# THE ENTRANCE PENINSULA

## COMMUNITY PRECINCT

27 November, 2011

**SUBJECT: TEEPCP'S SUBMISSION ON THE ENTRANCE MASTERPLAN**

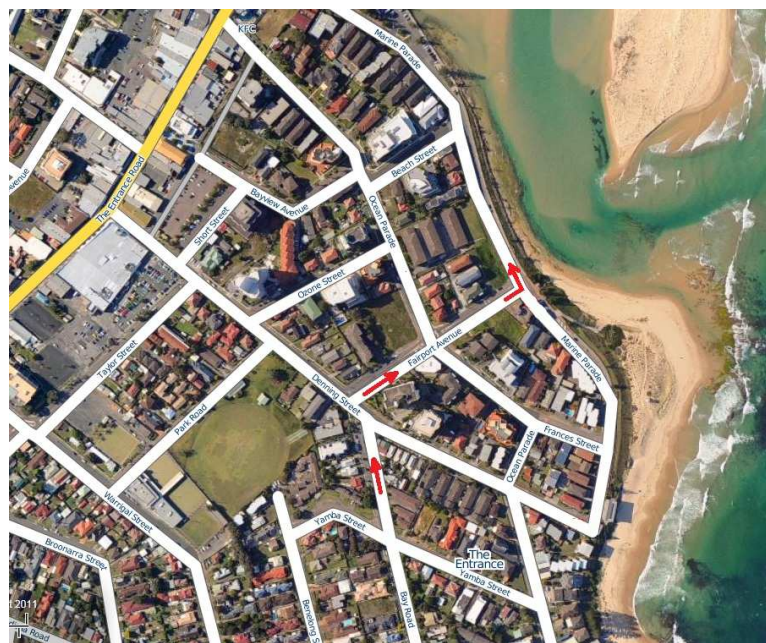
3.1.3 The possibility of replacing the Coral Street and Torrens Avenue roundabout with traffic control signals should also be considered on the grounds of pedestrian safety.

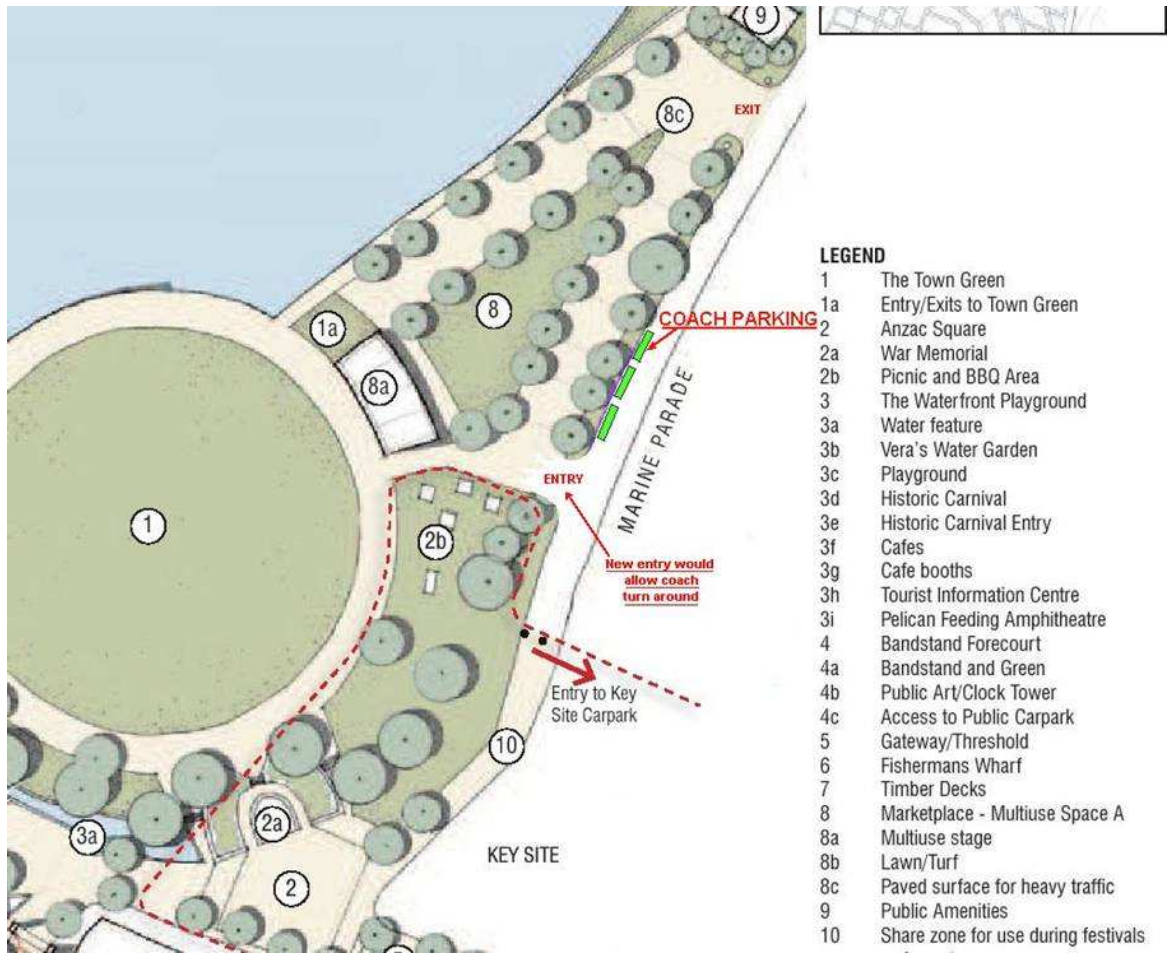
- 3.2.1 The contract for the Hydrodynamic Study at The Entrance is about to be awarded. A proposal like the Sunshine Bridge will also need detailed engineering and hydrodynamic studies.
- 3.2.2 Market Place and the Village Green need access to tourist coaches. They would have to access the site by Bay Road and Fairport Avenue and Marine Parade to give the tourists access to the Town Green ( Memorial Park ). At present they pull up in Marine Parade and use the BBQ.

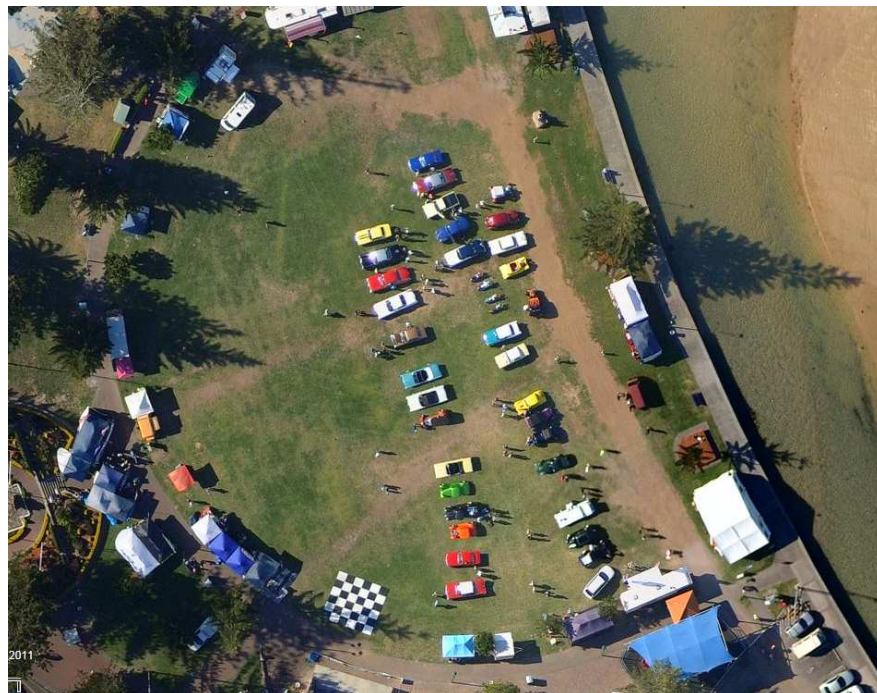
It would require modification to the entry and exit to "Marketplace" as shown below to allow the coaches to turn around.
